**MEMORANDUM**  
**January 6<sup>th</sup>, 2016**

**TO:** Landmarks Board

**SUBJECT:** Public hearing and consideration of a Landmark Alteration Certificate application to demolish an existing house built in 1957 and, in its place, construct a new 2,438 sq. ft. house at 2110 4<sup>th</sup> Street in the Mapleton Hill Historic District, per section 9-11-18 of the Boulder Revised Code (HIS2015-00254).

Figure 15. Proposed Site Plan

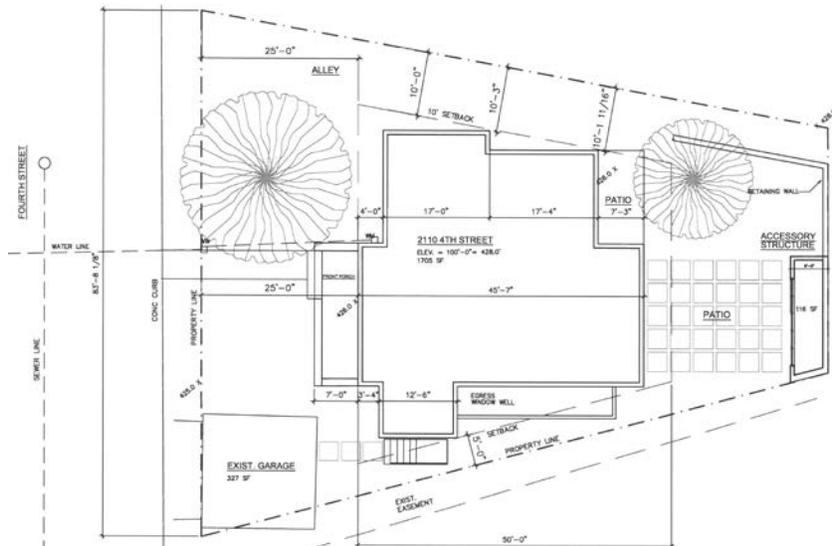
In plan, the proposed new house is shown to be located at approximately the same location as the existing house. The existing house is located approximately 26' from the west property line and the proposed house is shown to be located at the 25' front yard setback. The existing house measures approximately 35' wide and 26' long, with a 21' by 8' shed-roof portion located at the rear of the house. The proposed house is shown to

measure 45'-7" long and approximately 49' wide with the north wall creating an oblique angle to the north property line which runs adjacent to the Farmer's Ditch. Currently, the driveway provides access to at least one property to the east, although there is no dedicated easement providing that access. The existing contributing garage is shown to be maintained in its current location.

The site plan indicates construction of rear retaining walls, a rear patio and a 116 sq. ft. accessory building, (no elevations provided). No information was provided as to whether any changes to the contributing garage are contemplated as part of this project.

Figure 16. Proposed west elevation (façade)

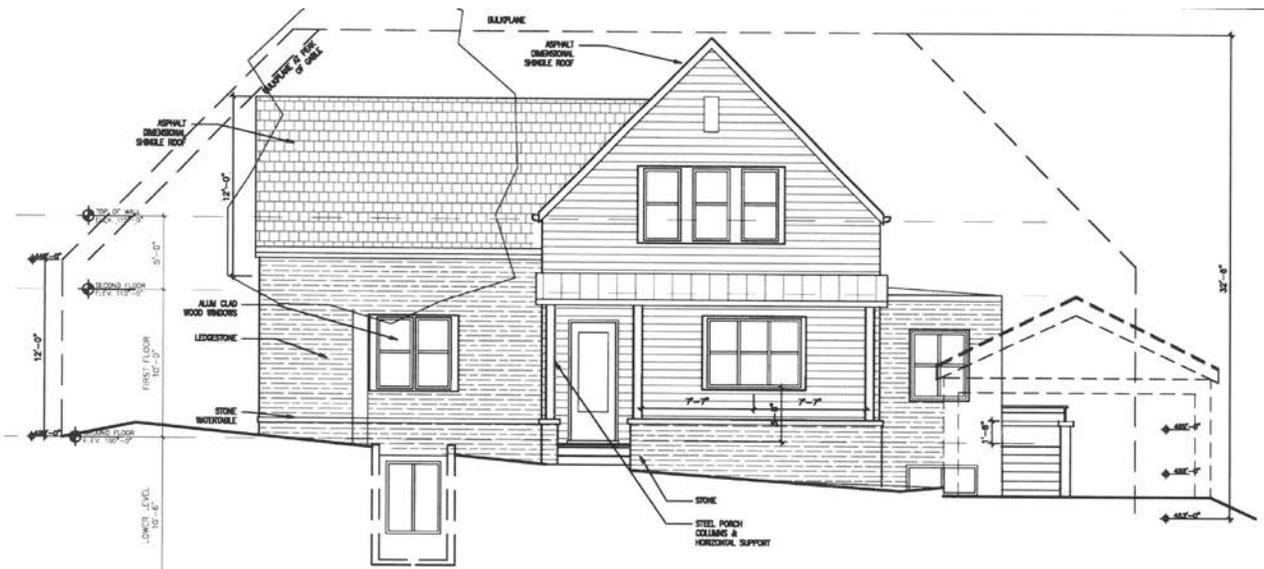
The first floor of the façade (west elevation), is shown to be fenestrated with ¾ light door on the porch and a set of one-over-one double hung sash and pairs of similar windows on the west face of the north and south portions of the house. A set of three one-over-one double hung sash is shown on the west upper-gable. A light-well is indicated at the north end of the west elevation, however, this feature does not appear on site or floor plans. Likewise, a basement window on the south ell on the west face is

shown to rise several feet above grade, but a window well in this location is not shown in plan.

- a. Consistent with the *General Design Guidelines* and the *Mapleton Hill Historic District Design Guidelines*; and
  - b. Consistent with neo-traditional interpretations of the Edwardian Vernacular, including redesign to minimize the visual impact of the clerestory windows at the north and south so that all windows are traditionally proportioned, scaled and profiled, reconsider wall cladding materials to eliminate the use of stone other than on the foundation, elimination of standing seam roof on the porch, elimination of the bronze fascia detail, and redesign of the east gable to be more consistent with neo-traditional interpretations of the Edwardian Vernacular in fenestration and materiality.

Figure 19. Proposed east (rear) elevation

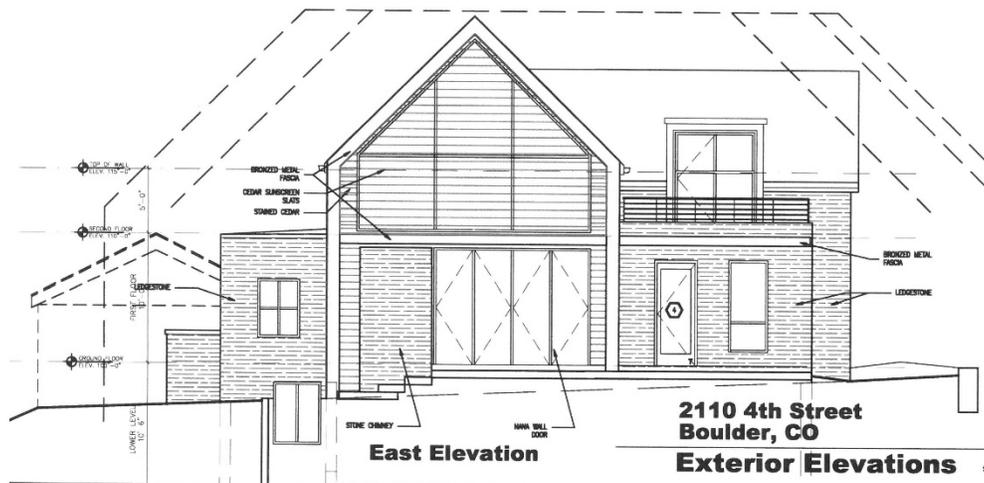
The east (rear) face of the house shows stained cedar sunscreen slats to cover a considerable portion of the gable area while a set of four French doors is proposed to provide access to a patio area on the ground level. The rear deck area is shown to be accessed by a set of French doors while fenestration at the ground level of the north portion of the house is shown to consist of a single-light door and double hung window. A four-light casement window and light well are shown at the south end of the east face.

Proposed Exterior Material Palette

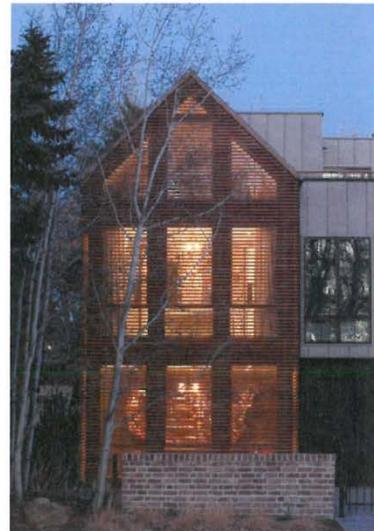
<i>Guideline</i>	<i>Analysis</i>	<i>Conforms?</i>
.1	<i>Materials should be similar in scale, proportion, texture, finish, and color to those found on nearby historic structures.</i>	Proposed materials include wood clapboard siding, “ledgestone”, stained cedar, asphalt shingle and standing seam metal roofing, metal clads windows and doors, copper fascia. Use of stone for wall cladding relatively rare in Mapleton Hill. Likewise, use of stained wood elements, copper fascia and standing seam roof not common. Consider revision to simplify material palette including	Maybe

use of stone cladding, fascia, porch roofing. Provide detailed information on all materials including proposed path ways, patio and retaining walls. Review at Ldrc.	
.2	<i>Maintain a human scale by avoiding large, featureless surfaces and by using traditionally sized building components and materials.</i>	Publicly visible elevations appear to meet this guideline.	Yes
